Review Comment Table

Board:	MVLWB
Review Item:	Pine Point Mining Limited - Land Use Permit and Water Licence Applications (MV2020L8-0012 MV2020C0017)
File(s):	MV2020C0017 MV2020L8-0012
Proponent:	Pine Point Mining Limited
Document(s):	Engagement Log (278.65 kb) Engagement Plan V2.1 (285.36 kb) Land Use Permit Application (681.63 kb) Project Description (4.78 mb) Screening Impact Assessment (7.1 mb) Studies Undertaken to Date and Traditional Knowledge (232.88 kb) Spill Contingency Plan V1.0 (7.1 mb) Waste Management Plan V.1 (761.49 kb) Wildlife Protection Plan V1.0 (1.6 kb) Water Withdrawal Plan V1.0 (53.9 kb) PPML RECLAIM Estimate (550.5 kb) Closure and Reclamation Plan V1.0 (2.92 mb) Mapbooks with Overview (4.95 mb) Bedrock Sampling Management Plan Framework (552.84 kb) Application Cover Letter (522.8 KB) Water Licence Application (630.75 kb) Groundwater Management Plan Framework (701.23 kb) Work Plan Version 1 (259.8 KB) Proposed Draft Permit Conditions by PPML (392.13 kb) Proposed Draft Licence Conditions by PPML (341.27 kb)

Figure 1. Boreal caribou GPS collar locations colour-coded by behavioural season from 27 individuals collared between 2015 and 2020, and are collected every 2 hours between April 29 – June 08, and every 8 hours for the remainder of the year.

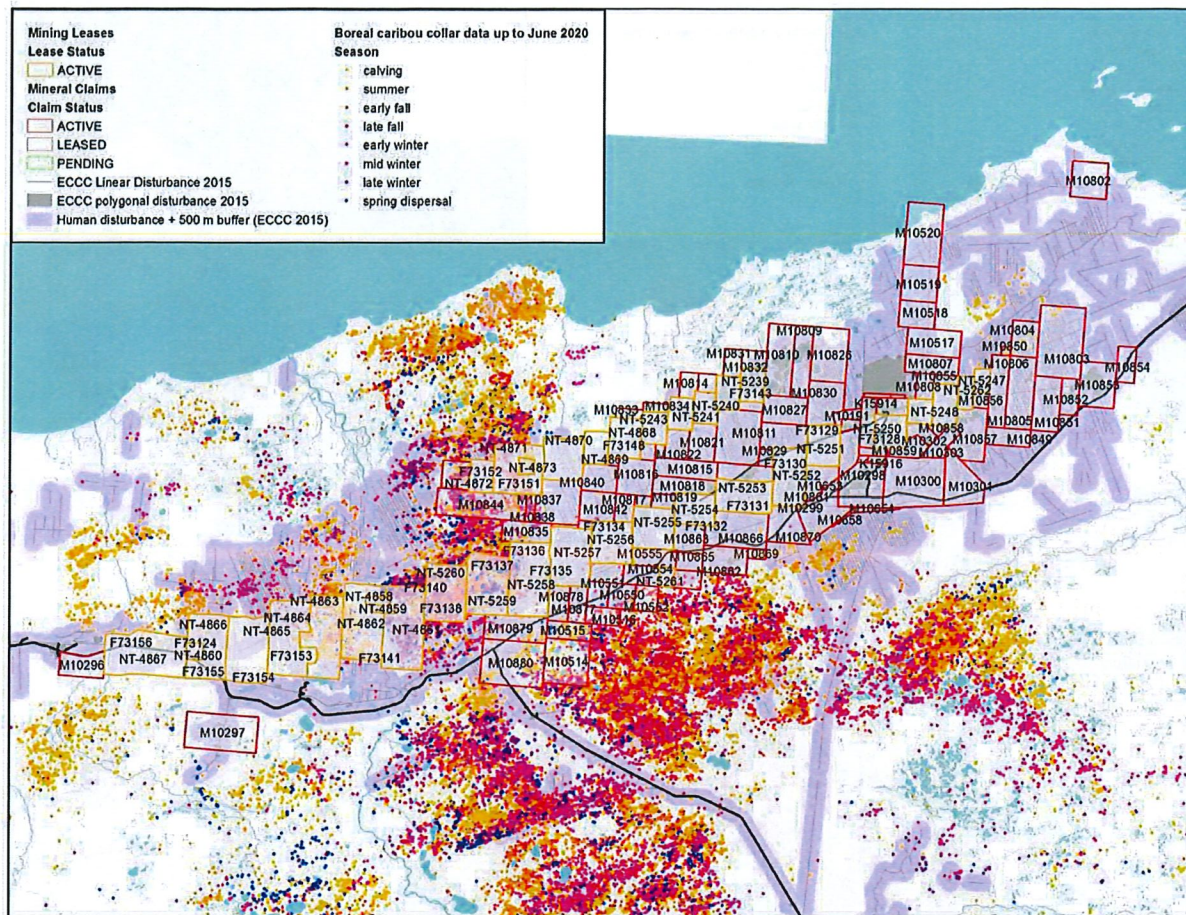
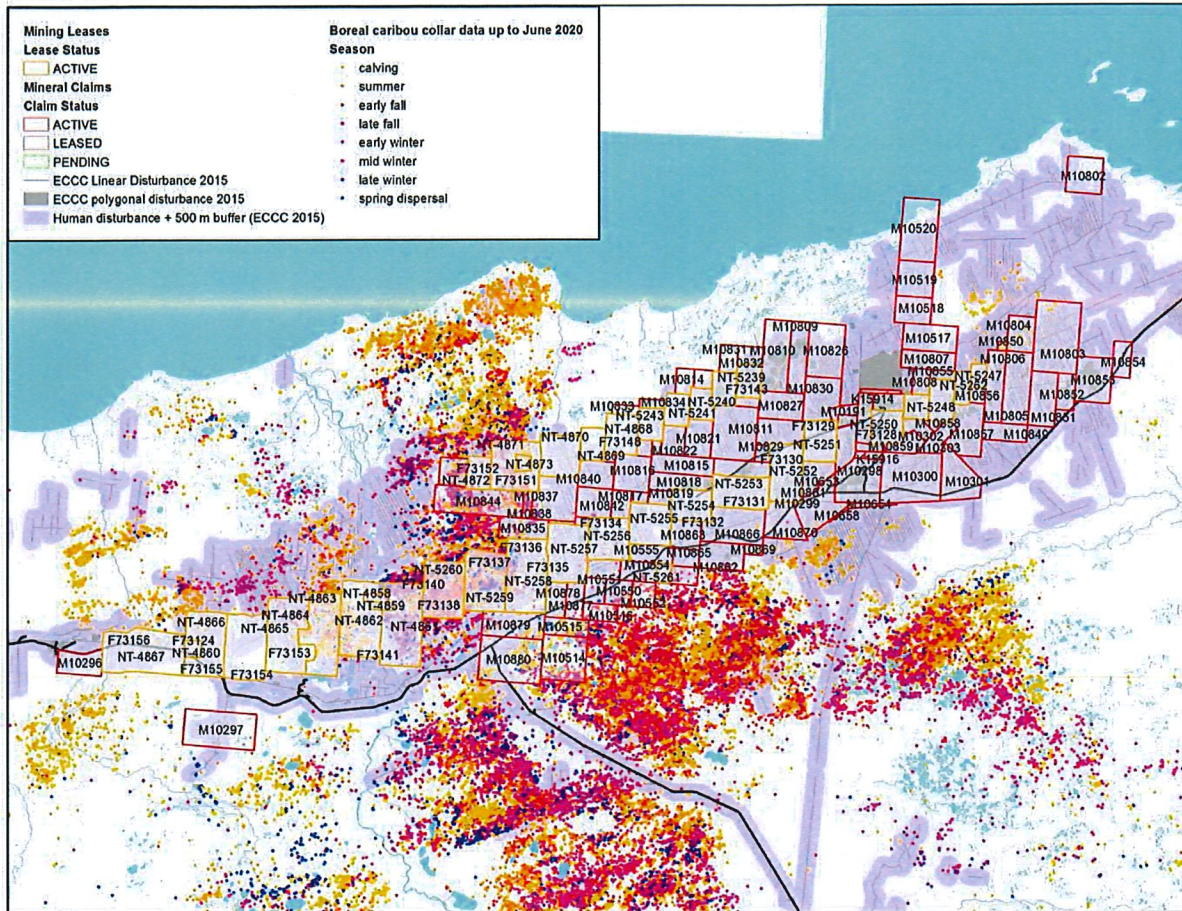
western half of PPML's mineral leases and mineral claims, with a prominent north-south movement corridor across mineral leases NT-4858, NT-4859, NT-5258, NT-5259, NT-5260, NT-4861, NT-4862, NT-4863, NT-4864, NT-4871, NT-4872, and NT-4873, and mineral claims (those that don't overlap with the mineral leases listed above) M10835, M10837, M10838, M10842, M10844, M10845, M10550, M10551, M10552, M10553, M10554, M10862, M10868, M10869, M10877, M10878, M10879, M10880, M10514, M10515, M10516. Figure 3 illustrates the minerals leases and claims with the highest densities of collar locations. Although PPML's Screening Impact Assessment acknowledges that the project area overlaps with the range of boreal caribou, it is insufficient to properly assess the impact of their operation on the local boreal caribou population. The screening assessment identifies that there will be direct habitat loss, sensory disturbance to wildlife, and potential for direct mortality; however, it does not specifically assess the potential significance of these impacts on boreal caribou, nor does it consider the cumulative impacts of their project alongside other past, present and reasonably foreseeable developments in the context that boreal caribou is a threatened species in the NWT. PPML's Screening Impact Assessment concludes that most effects will be localized, and reversible, based on the assumption that many potential impacts will be mitigated by preferentially using previously disturbed areas. Given that much of the disturbance in the western portion of the project area consists of narrow linear features (likely trails associated with former prospecting and exploration activities) that may have regenerated sufficiently to be used by caribou, relying on preferential use of historic disturbances may not offer the mitigation advantage it might in other areas. The extent of new habitat disturbance that will result from creating new access and clearings for various activities, as well as clearing of existing narrow and partially-regenerated trails to a width of 10 m, has not been adequately quantified in PPML's application. The duration, timing, frequency, and location of activities that will cause sensory disturbance to boreal caribou (drilling, blasting, excavating, hauling, etc.) also

Attached to this letter are three figures showing collar locations and movement paths of individual boreal caribou colour coded by behavioural season. Figure 1 and Figure 2 display movement data from 27 caribou collared between 2015 and 2020, and indicate year-round use of the western half of PPML's mineral leases and mineral claims. Figure 3 illustrates the minerals leases and claims with the highest densities of collar locations (see Appendix A for more details).
